April 12<sup>th</sup>, 2016

**SUBJECT:** Recommendations for Consideration by the Minnesota Committee on Uniform Traffic Control Devices to Revise the Minnesota Manual on Uniform Traffic Control Devices for Temporary Traffic Controls on Low Volume Streets and Highways

Figure 1 – Recommendation Examples

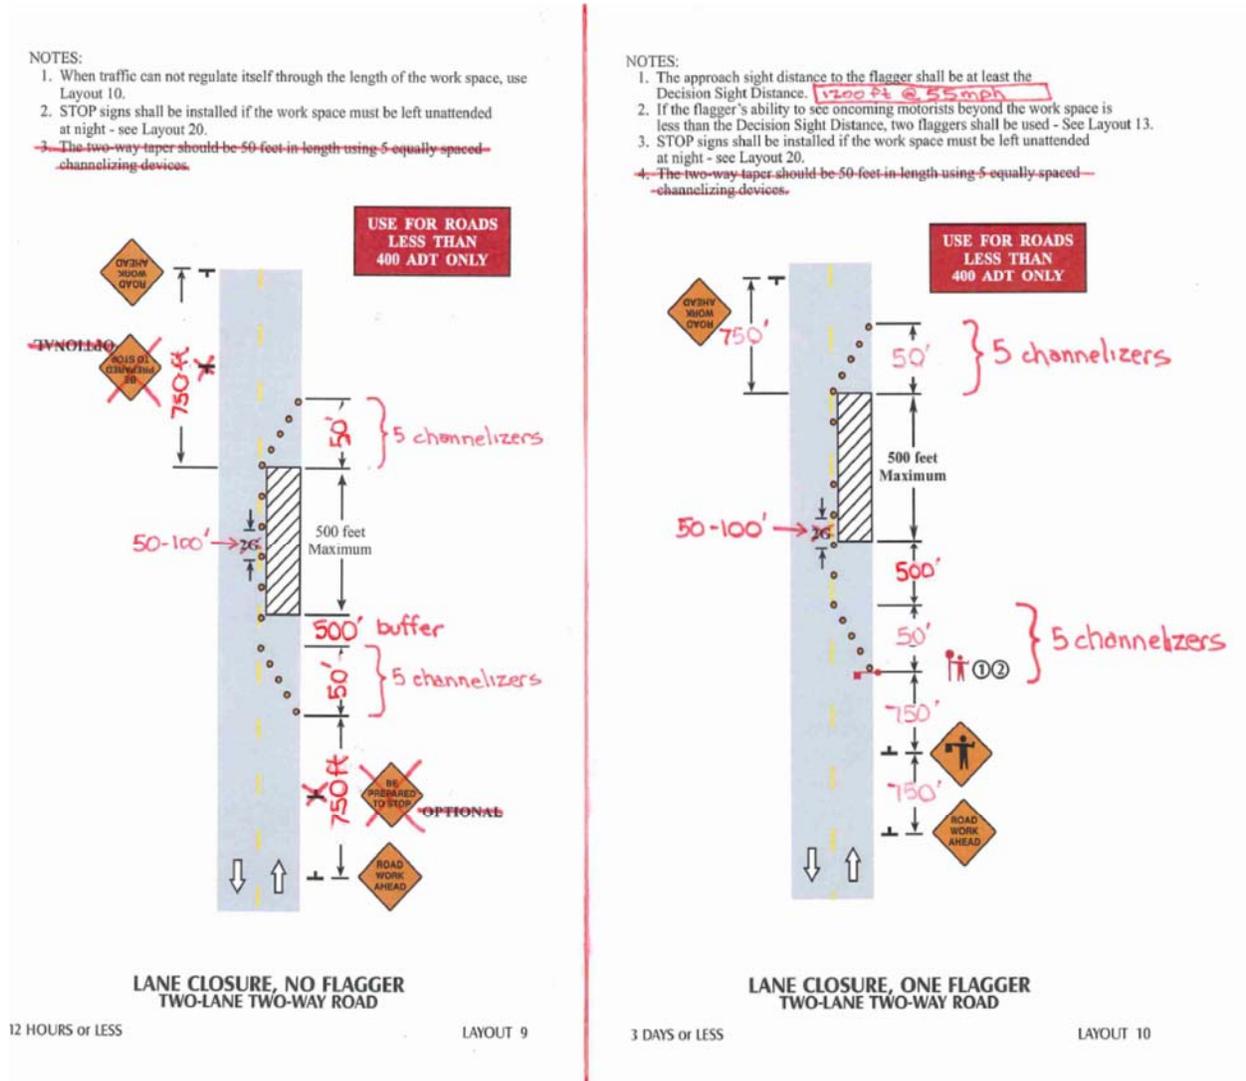
The applications and layouts for low volume rural highways are scattered throughout the Field Manual. To facilitate use by local authorities, the Task Force recommends including a separate section in the Field Manual for low volume rural highways. This section would contain the existing Layouts 8, 9, 10, 11, 20, 21, 23, and 72. Since most of these rural highways have statutory speed limits of 55 mph and many are not posted, the Task Force also recommends showing distances directly on the layouts rather than referring to the device spacing charts. It is further suggested that all optional devices be removed from the layouts. Figure 1 shows these recommendations applied to the existing layouts 9 and 10.
